# TECHNICAL MEMORANDUM

**To:** Jeff Rice, PE, El Paso County  
**From:** Mike Bramlett, PE, JR Engineering, Engineer of Record  
**Date:** August 16, 2023  
**Subject:** Sand Creek Channel Resubmittal – Design Support Memo

Model layout for WS & Shear flow analysis except in FIS flow condition

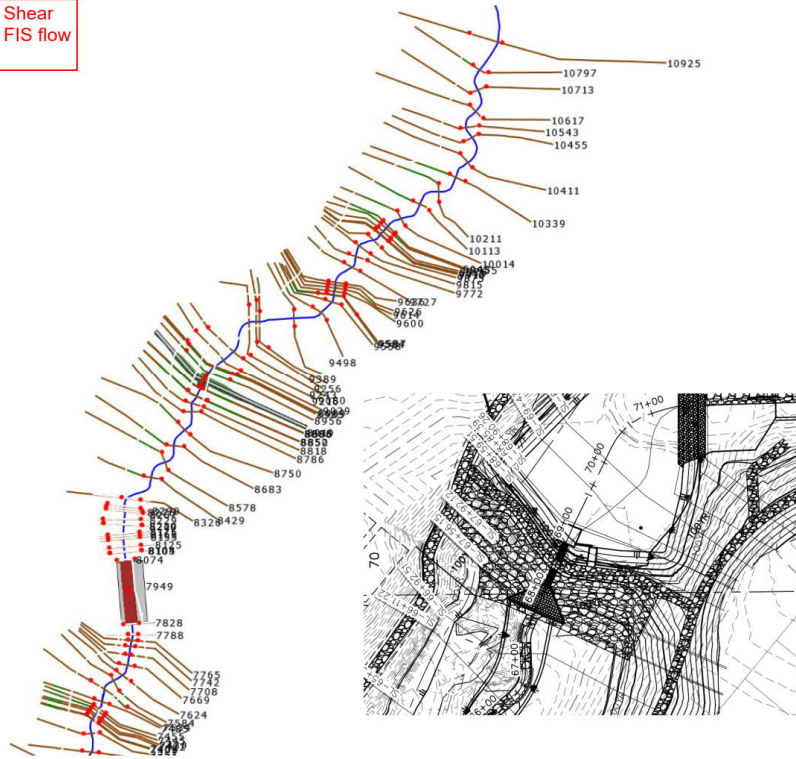
Cross Section 88+50 – This cross section is the pond 2 sill wall north of Briargate Parkway. JR has added a low flow notch to the sill wall detail which greatly reduced the slope from sill wall lip to low flow channel which improved the shear force. In the current HEC RAS shear analysis, the 100 year design flow shear has reduced from the previous 14 lb/sq.ft result to 2.55 lb/sq.ft. in the low flow channel and this area has been armored. Details for this area are shown on page 30, 50-52 and 115 of the channel plans. HEC RAS shear analysis results are on page 191 of the design report. See below for a general location of the cross section;

Model layout for WS & Shear flow analysis except in FIS flow condition

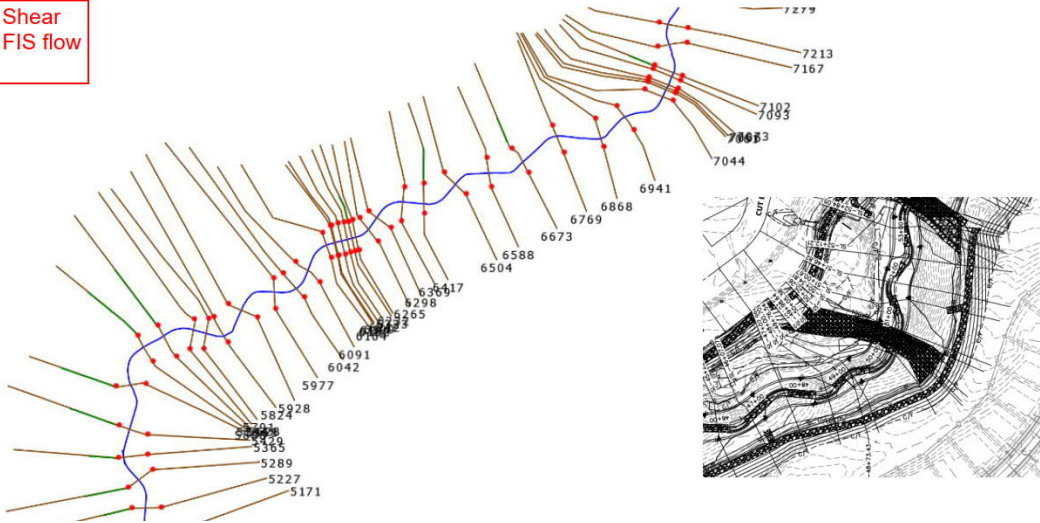
Cross Section 70+44 – This cross section is approximately 15 feet below the GSB 4 sill wall and the previous HEC RAS shear analysis (5 year) showed a Froude number of 1.68 or supercritical flow. JR has added a low flow notch to the sill wall detail which greatly reduced the slope from sill wall lip to low flow channel. In the current HEC RAS shear analysis, neither the 5 year nor 100 year design flows show a Froude number above 0.89. Details for this area are shown on page 30, 50-52, 58 and 114 of the channel plans. HEC RAS shear analysis results are on page 195 of the design report. See below for a general location of the cross section;

Model layout for WS & Shear flow analysis except in FIS flow condition

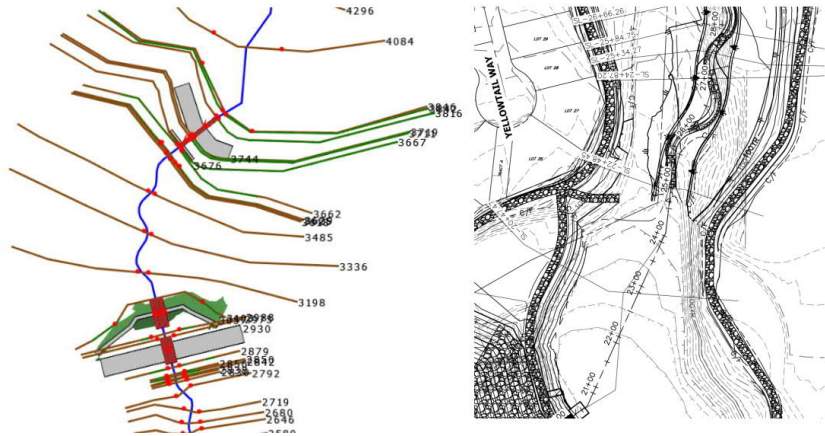
Cross Section 42+96 – This cross section is within Pond 1 and is inundated in the 5 year flow design case. The current HEC-RAS shear analysis continues to show velocities above 7 feet per second however, JR believes this is not what will occur in either the 5 year or 100 year storm scenario since this is a ponded body of water and JR is not concerned with erosion in this area. We believe it is a result of the natural bottom slope of the existing pond bottom but have been unable to tweak the model to improve the resultant velocities. Details for this area are shown on page 27 and 112 of the channel plans. HEC RAS shear analysis results are on page 198 of the design report. See below for a general location of the cross section;

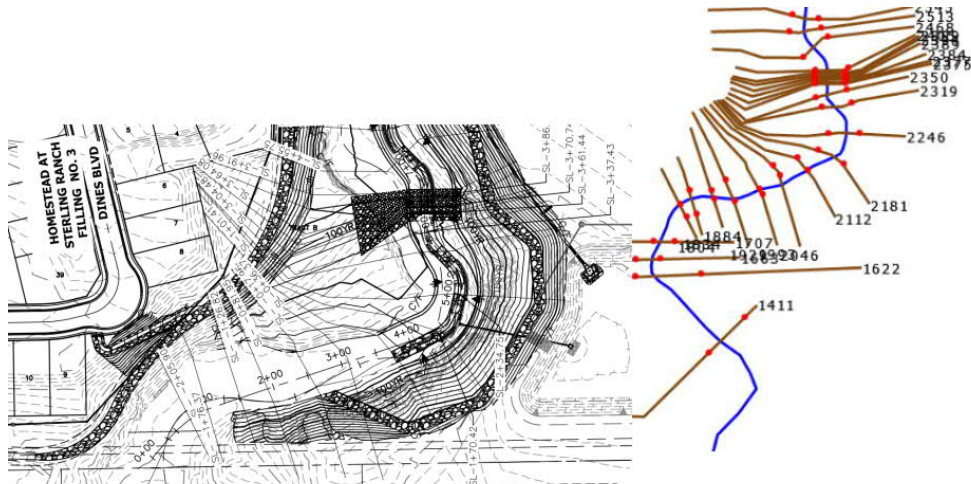
Cross Section 18+84 and 18+04 – These two cross sections are at the southern limit of the channel improvements where the channel swings south and is generally unimproved. The velocities are approaching 9 ft per sec and shear is less than 2 lb/sq.ft. in the 100 year shear analysis. This situation can be rectified if the channel south of Sterling Ranch is ever improved. To protect Sterling Ranch development and stabilize this section, JR has added sheet pile cut-off wall just downstream and in this new re-submittal permanent geotextile matting is proposed over the channel bottom to provide erosion protection and stabilization. Details for this area are shown on page 26 and 111 of the channel plans. HEC RAS shear analysis results are on page 201 of the design report. See below for a general location of the cross sections;
